Canterbury Regional Council for
resource consents to take and use
water from the Waimakariri and
Rakaia Rivers and for all associated
consents required for the
construction and operation of the
Central Plains Water Enhancement
Scheme

**RESPONSE TO SECT. 42A OFFICERS' REPORTS
JULIAN JAMES WEIR**

RESPONSE TO OFFICER'S REPORT BY DAVID SCOTT

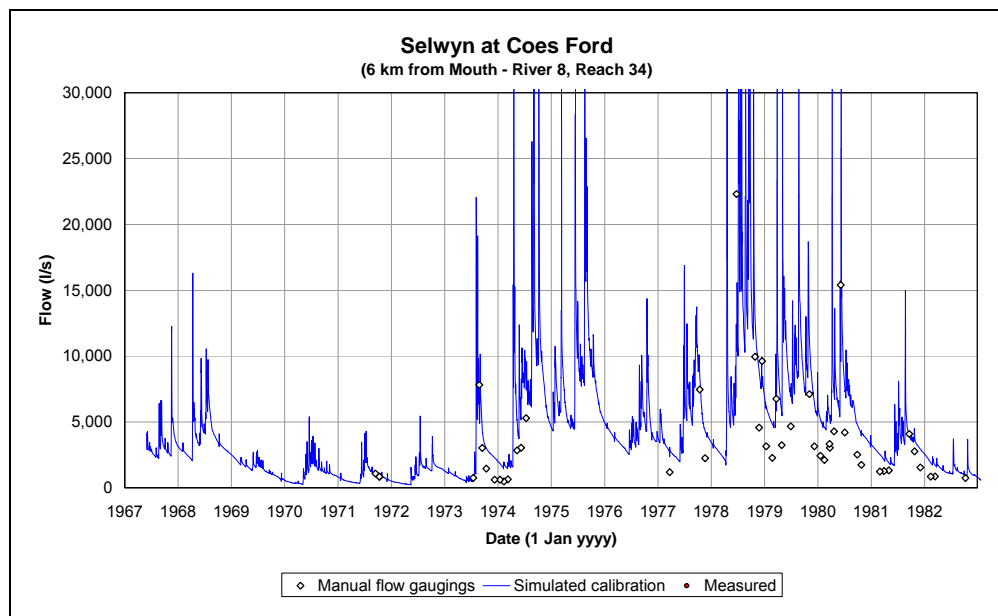
27. Para 27: Mr. Scott is quoting paragraph 3 on page 18 of the review and has taken this quote out of context. The full quote is reproduced next with the part missing from Mr. Scott's report highlighted in bold: ***'It is unusual to get accurate replication of river flows in a groundwater model, as flows have more than a baseflow component and the river algorithm is usually simplified. Some flow duration curves and cumulative flow curves show divergences. However, one could not expect matches to be any better than this.'***
28. Para 29: I was not aware of this data at the time of model calibration and consequently calibration focussed on the recorder data from 1984 onwards. However, I make the following comments:
 - The very low flows of the early 1970's and early 1980's match well.

- The higher low flows in the late 1970's don't match as well as the very low flows, but there is still a reasonable comparison between measured and modelled. Trends are certainly matched well.
- The Selwyn River bed at the Coes Ford recorder and gauging site is highly variable, moving and shifting over time. The groundwater model does not account for this variability.
- There is little information relating to the accuracy of these earlier gaugings. Many factors would influence the measurements, including surface water takes upstream of the gauging site.
- The model matches well to the few higher flow gaugings during the late 1970's. This is seen in the following plot which focuses on the period 1967-1983 with an enlarged vertical axis.

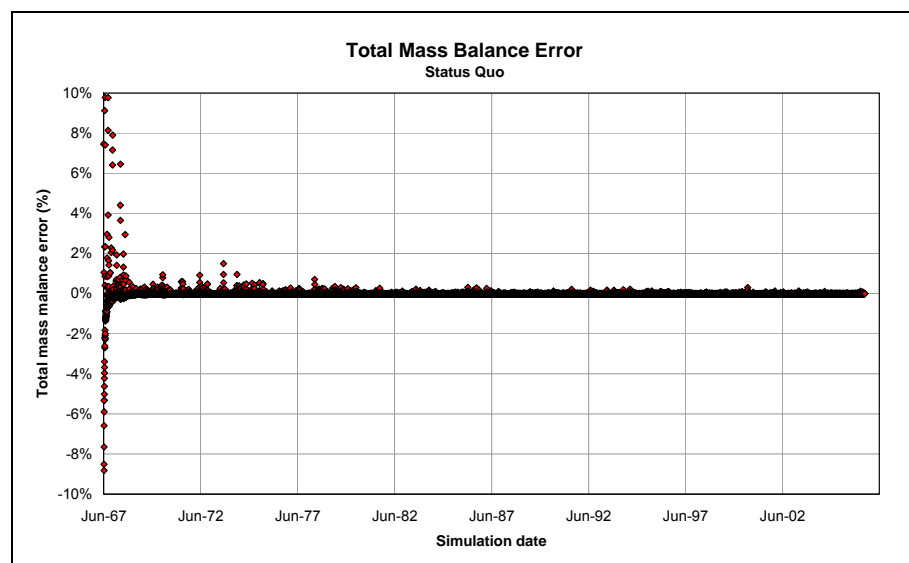
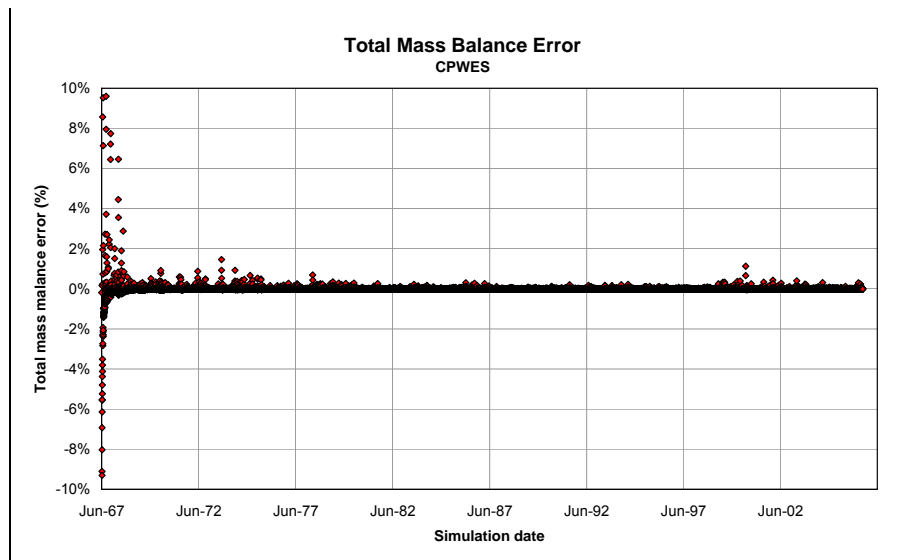
32. Paras 32-34: Mr. Scott has considered the mass balances out of context. In paragraphs 91 and 186 of my main evidence, I state that the mass balance totals are indicative only and have been provided to show how the overall water balance changes with the inclusion of the CPWES. In paragraph 89 of my main evidence, I discuss how after the first 1-2 years of the simulation, total mass balance errors for the transient calibrated model are much less than 2%, with most time periods reporting mass balance errors of 1% or less. However, I did not present the equivalent information for the two development scenarios run to consider the effects of the CPWES. This is provided in the following paragraph.

33. Paras 32-34 cont.: Total mass balance error versus simulation run time for the two development scenarios are provided below. In both cases, after the first 1-2 years of the simulation, mass balance errors are much less than 2%, with most time periods reporting mass balance errors of 1% or less, much like the calibrated model.

34. Paras 32-34 cont.: Given the above, the mass balance discrepancies are within the limits suggested by MfE (2002)⁴ as being acceptable.
